Phillips 66  
Bayway Refinery  
P.O. Box 222  
1400 Park Avenue  
Linden, New Jersey 07036

**NJPDES Permits NJ0001511**  
**NJPID #46318 & NJ0026671**  
**NJPID #46322 Report Response**

**Bayway Refinery**  
**February 24, 2020 Compliance Evaluation Inspection (CEI) Report**  
**NJPDES Permit Nos. NJ0001511 (PID #46318) & NJ0026671 (PID #46322)**

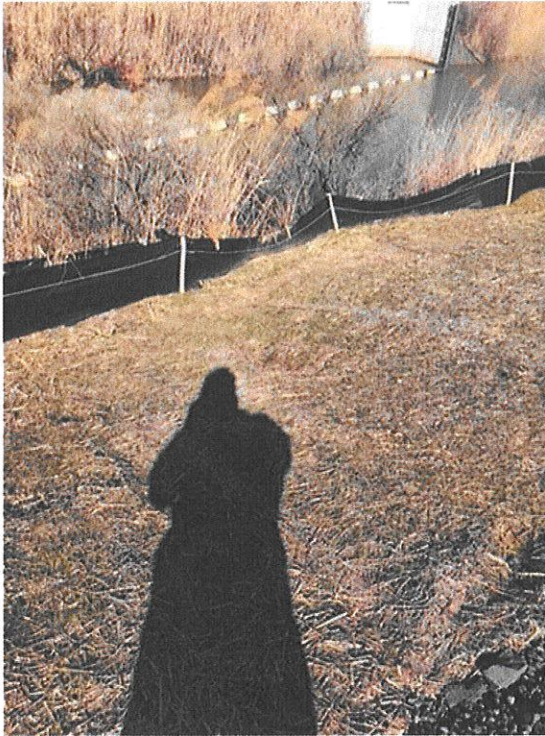
**7. The Exxon RCRA area had large amounts of unstabilized soils. There was some erosion seen near the silt fencing. Explain whether this area has been stabilized.**

Response: This USEPA Area of Concern was forwarded to ExxonMobil, who provided the following response and photographs (unedited in quotes):

We also note that the observed site remediation work and photographed areas were covered by ExxonMobil's NJPDES Individual Stormwater Permit Authorization for Construction Activity and the associated Stormwater Pollution Prevention Plan and certified Soil Erosion and Sediment Control Plan."
